**Government of India
(Ministry of Railways)
Research Designs & Standards Organization
Manak Nagar, Lucknow-226 011**

**SPECIAL MAINTENANCE INSTRUCTIONS
NO.RDSO/ELRS/SMI/0237 (Rev.'0')**

Modified layout of cables from TFP to RSI blocks to avoid chances of on line failure/ fire in conventional Electric Locomotives.

Annexure-II

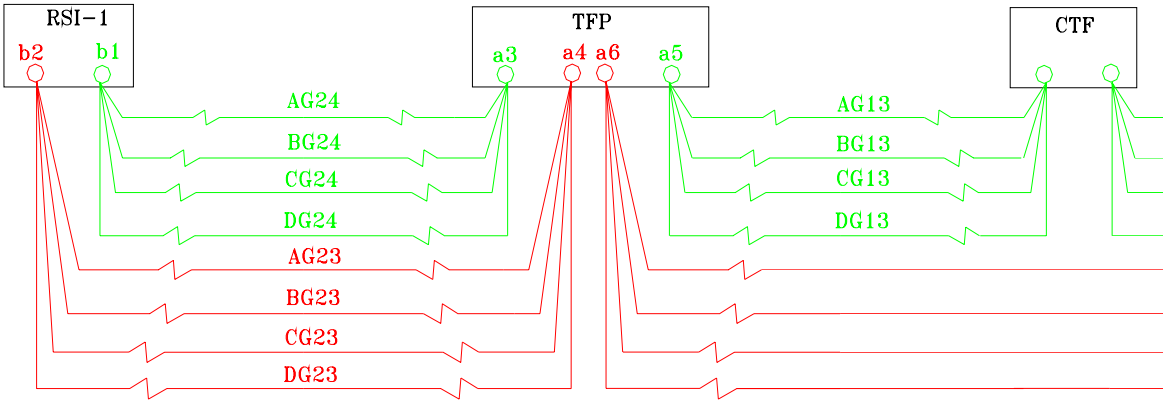
Measured Current with different Layout of cables

SN	Loco No.	Current drawn by Cables (Amps)				Remarks
		A	B	C	D	
1	27423 (Measurement at ELS/CNB)	304	495	327	176	2 nd Notch
		271	220	421	360	2 nd Notch, when two cables crossed each other
		252	263	382	286	2 nd Notch, when cables run parallel
		274	294	331	332	2 nd Notch, when cables twisted each other
		318	464	314	168	2 nd Notch with normal arrangement
		285	401	267	317	2 nd Notch when cables B & D interchanged
		346	345	318	217	2 nd Notch with single loop in all cables
